72+COLLINS DEVELOPMENT

CITY OF MIAMI BEACH
DESIGN REVIEW BOARD

MARCH 2, 2021

72 COLLINS HOTEL & CONDOMINIUM
MIAMI BEACH, FL

VARIANCES GRAPHIC

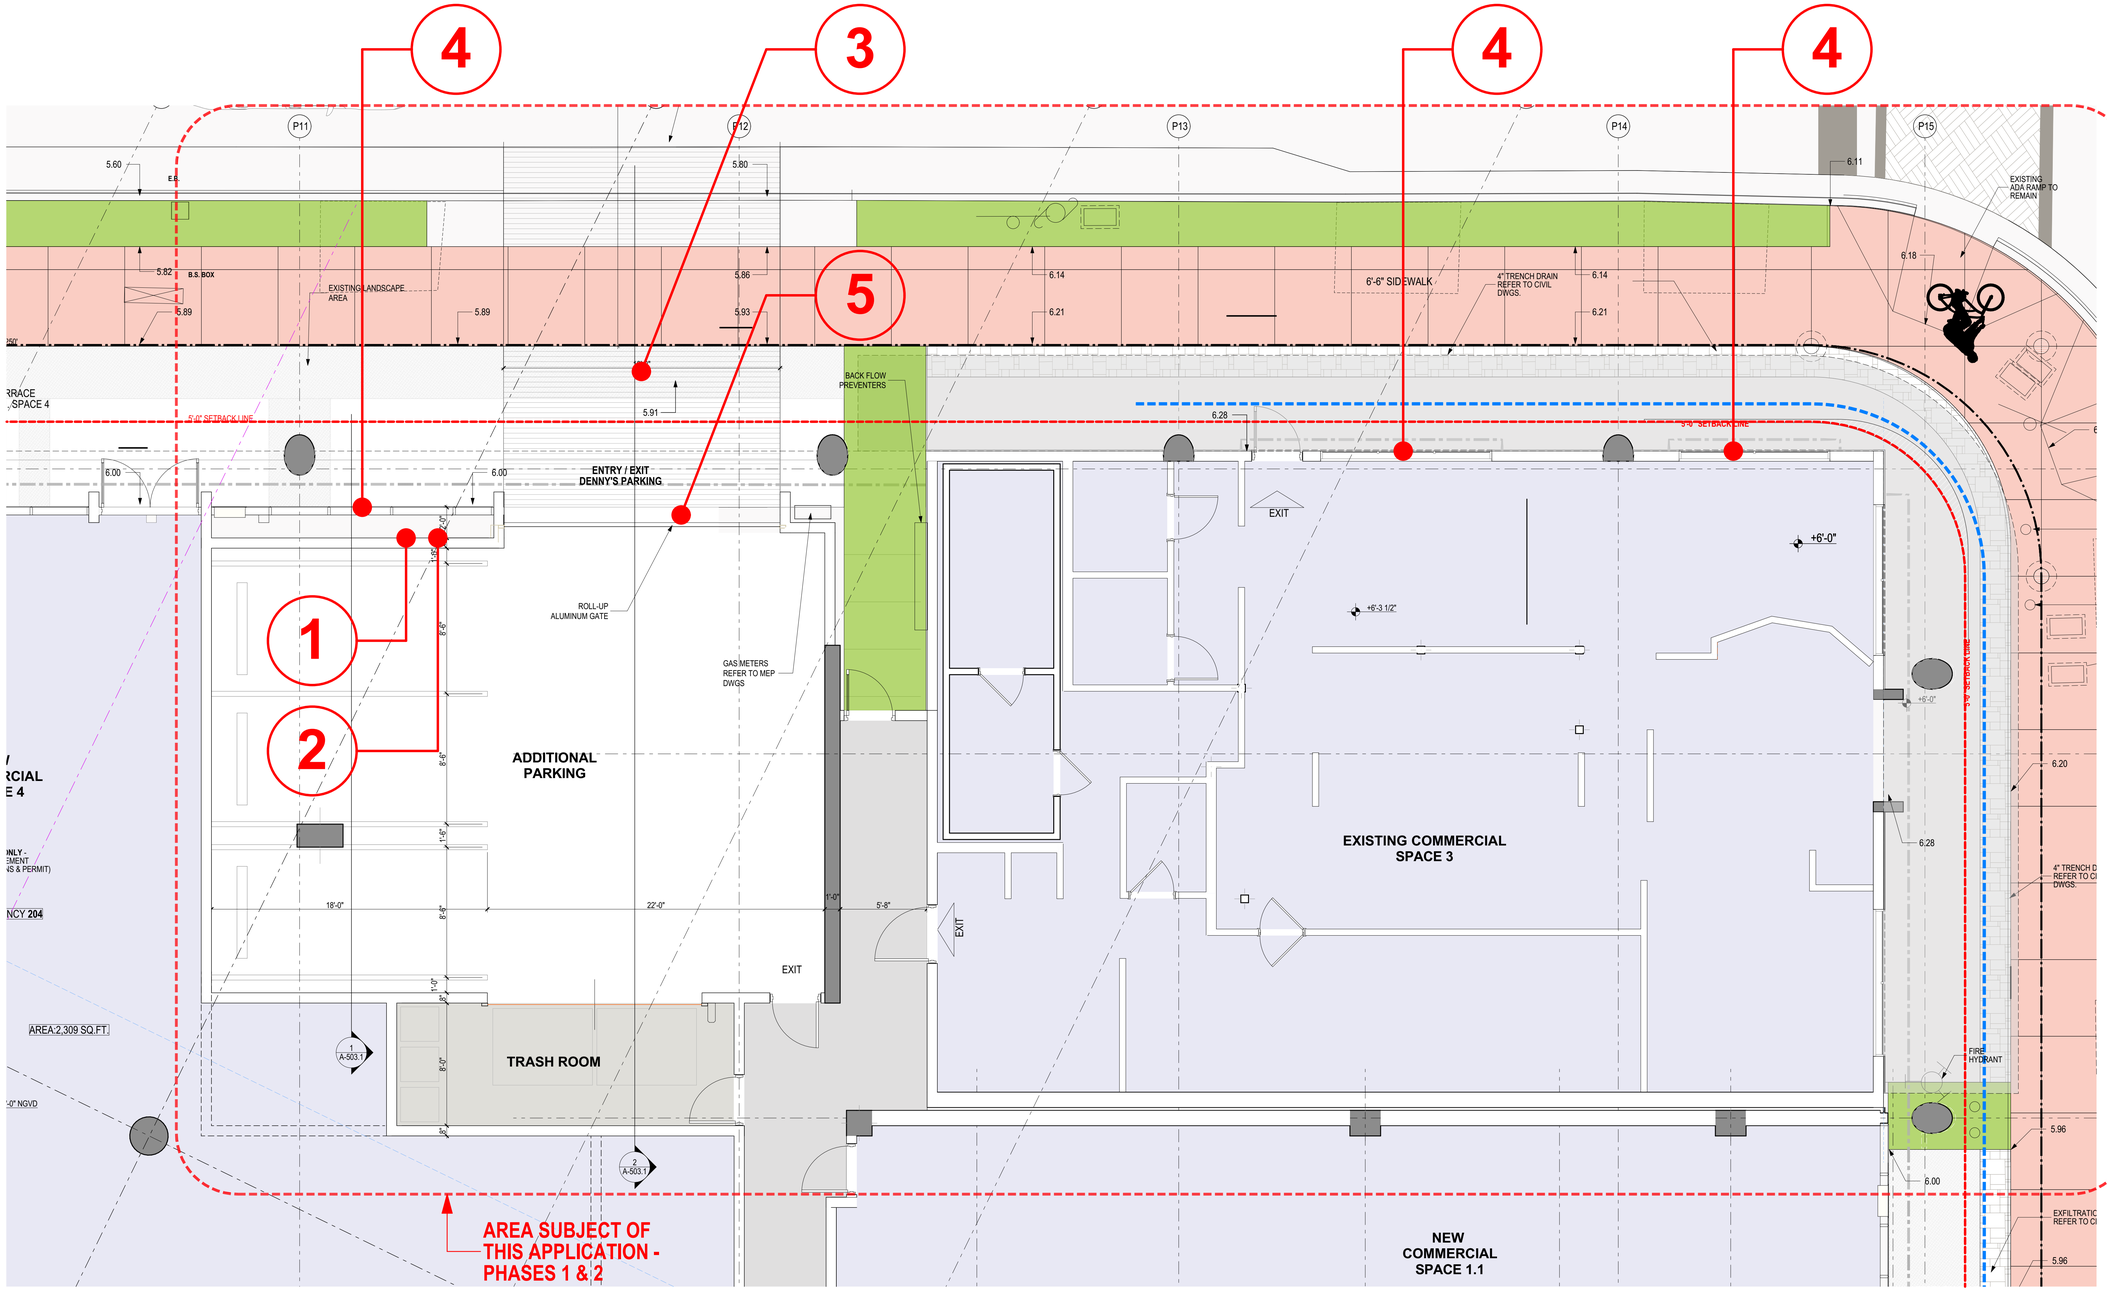
ALL OF THE VARIANCES ARE ONLY REQUIRED FOR THE **TEMPORARY PHASE 1** IMPROVEMENTS TO ACCOMODATE THE DENNY'S LEASE.

1. SEC. 142-745 (e)(2)(b). EXCEPT WHERE REQUIRED FOR DRIVEWAYS AND UTILITY INFRASTRUCTURE, THE GROUND FLOOR SHALL CONTAIN HABITABLE SPACE WITH A MINIMUM DEPTH OF 50 FEET FROM BUILDING FACADE. **2 FT PROVIDED.**

2. SEC. 142-745 (e)(2)(e). GROUND FLOOR AND SURFACE PARKING SHALL SETBACK A MINIMUM OF 50 FEET FROM THE BUILDING FACADE AND BE CONCEALED FROM VIEW FROM THE CLEAR PEDESTRIAN PATH. **2 FEET PROVIDED.**

3. SEC. 142-745 (e)(3). DRIVEWAYS AND VEHICLE ACCESS TO OFF-STREET PARKING AND LOADING SHALL BE PROHIBITED ON CLASS A FRONTAGE, UNLESS IT IS THE ONLY MEANS OF EGRESS TO THE SITE. **ONE DRIVEWAY PROVIDED ON 72 STREET, WHIS IS A CLASS "A" FRONTAGE.**

4. SEC. 142-745 (a)(8)(b). FRONTAGE FOR COMMERCIAL, HOTEL, AND ACCESS TO UPPER LEVEL FRONTAGE SHALL CONTAIN A MINIMUM OF 70 PERCENT CLEAR GLASS WINDOWS WITH VIEWS INTO HABITABLE SPACE. **21.56 % PROVIDED.**

5. SEC. 142-745 (a)(10)(a). PARKING FACILITIES SHALL BE ENTIRELY SCREENED FROM VIEW FROM PUBLIC RIGHTS-OF-WAY AND CLEAR PEDESTRIAN PATHS.

ELEVATION NORTH CORNER FACADE - PHASE 1

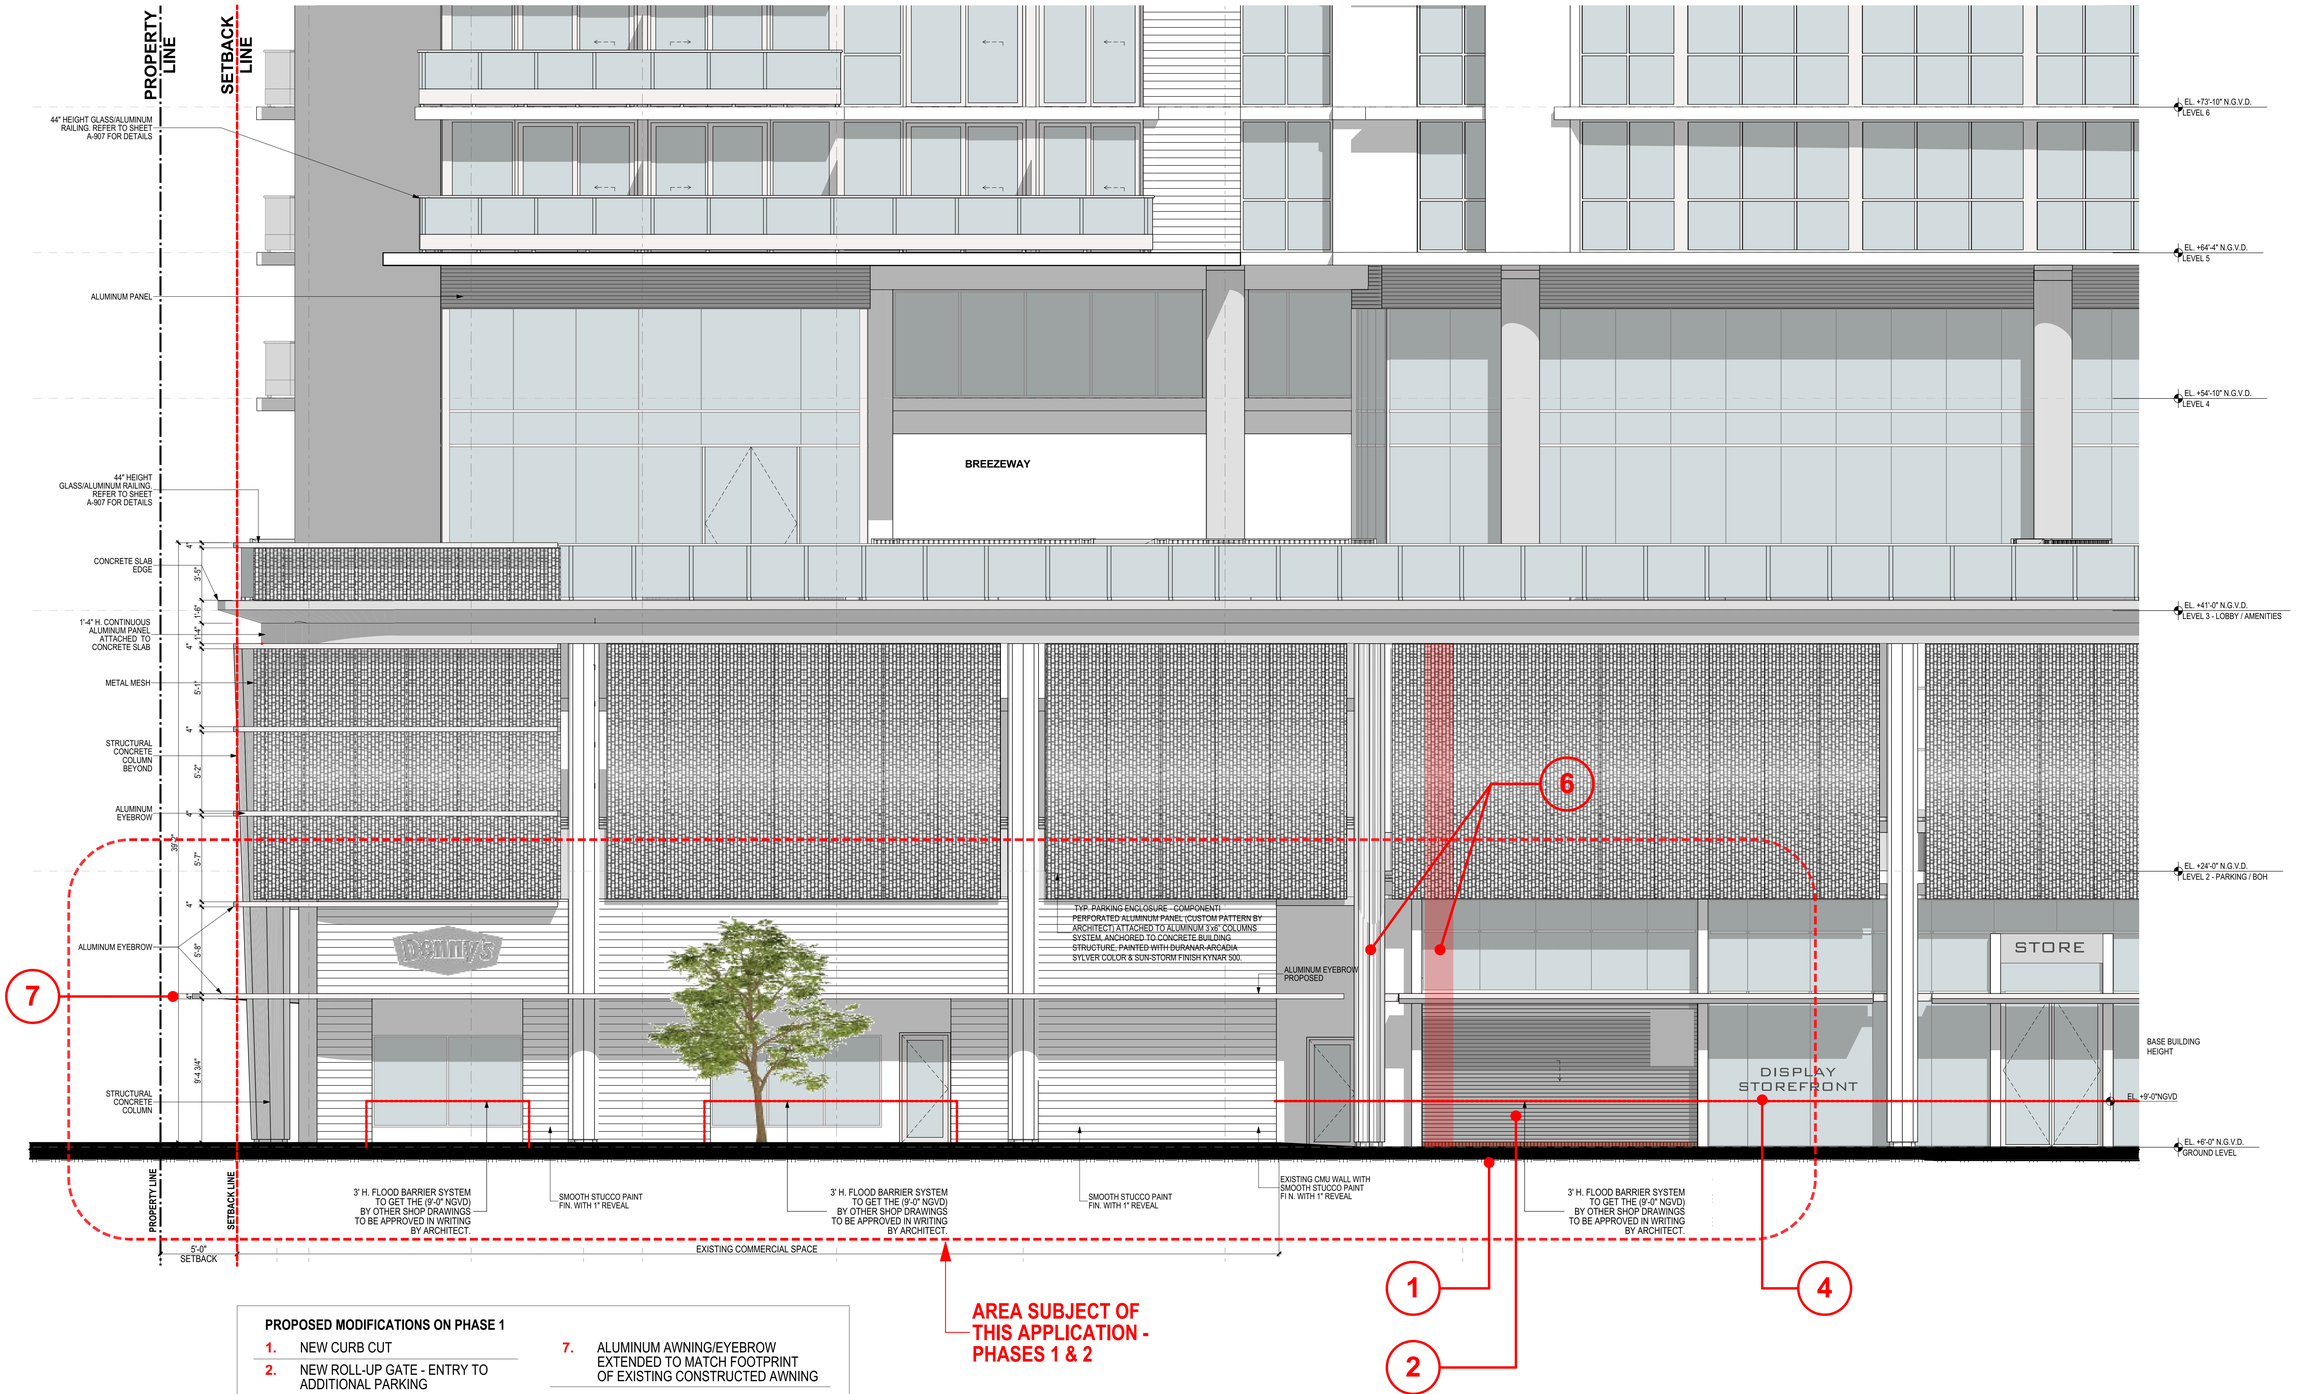
PROPOSED MODIFICATIONS ON PHASE 1

1.	NEW CURB CUT
2.	NEW ROLL-UP GATE - ENTRY TO ADDITIONAL PARKING
3.	Not used
4.	DISPLAY WINDOW
5.	Not used
6.	COLUMN RELOCATION
7.	ALUMINUM AWNING/EYEBROW EXTENDED TO MATCH FOOTPRINT OF EXISTING CONSTRUCTED AWNING

ELEVATION NORTH CORNER FACADE - PHASE 2

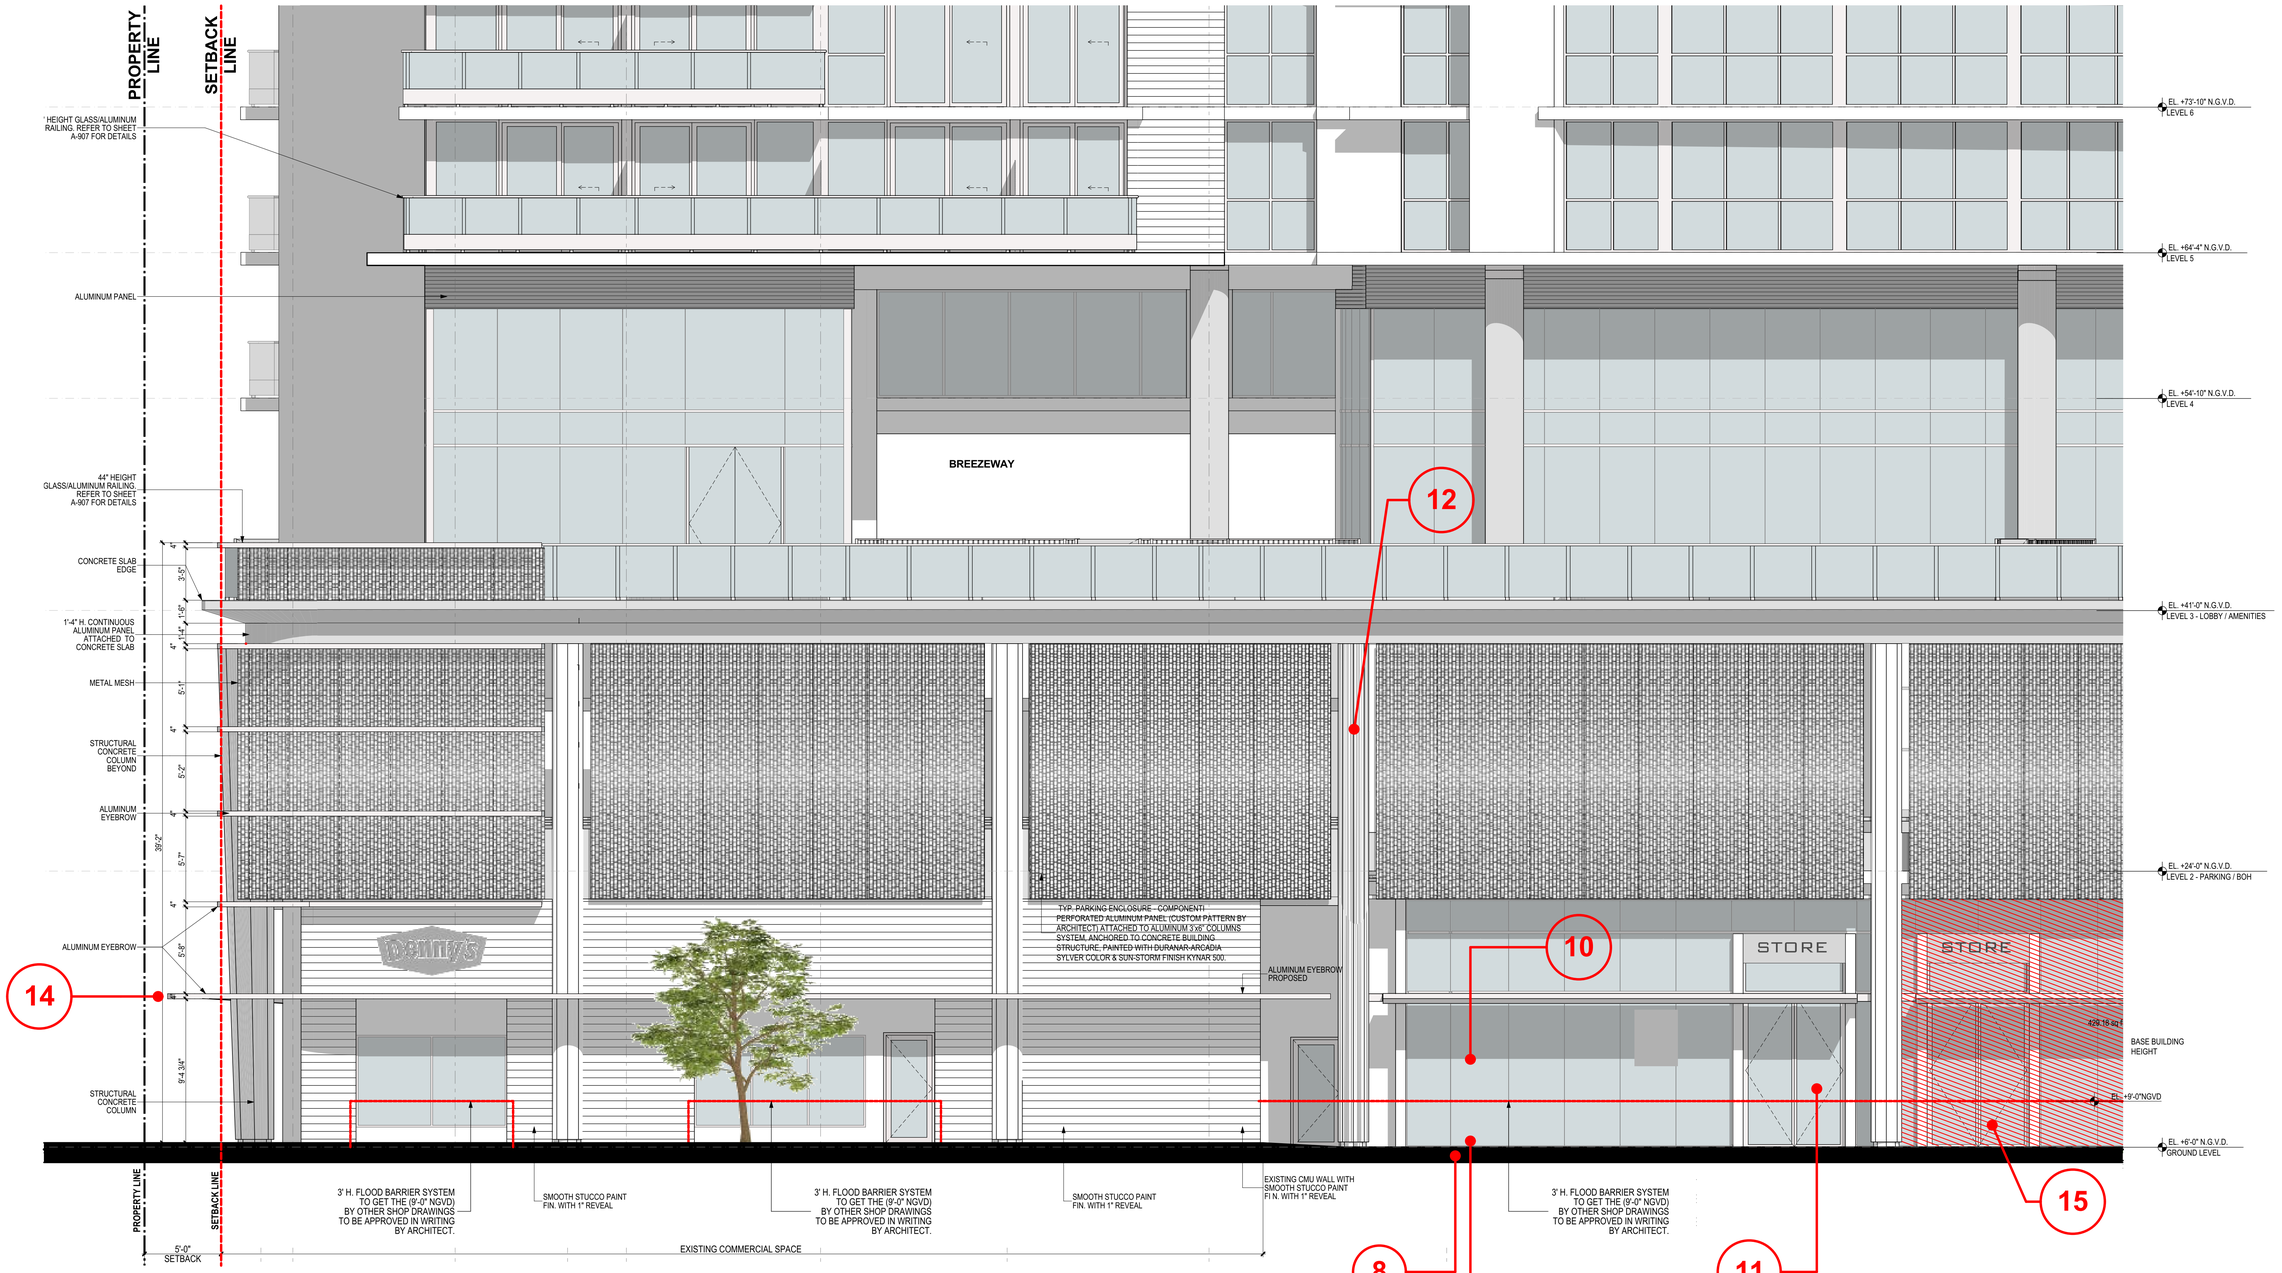
PROPOSED MODIFICATIONS ON PHASE 2

8.	CLOSING OF CURB CUT
9.	NEW LANDSCAPE AND HARDSCAPE TO MATCH ADJACENT AREAS
10.	REPLACE GATE WITH STOREFRONT
11.	INSTALL NEW RETAIL DOOR
12.	COLUMN REMAIN IN THIS LOCATION
13.	COMPLETION OF RETAIL SPACE
14.	ALUMINUM AWNING/EYEBROW DIMENSIONS REMAIN
15.	RELOCATION RETAIL DOOR
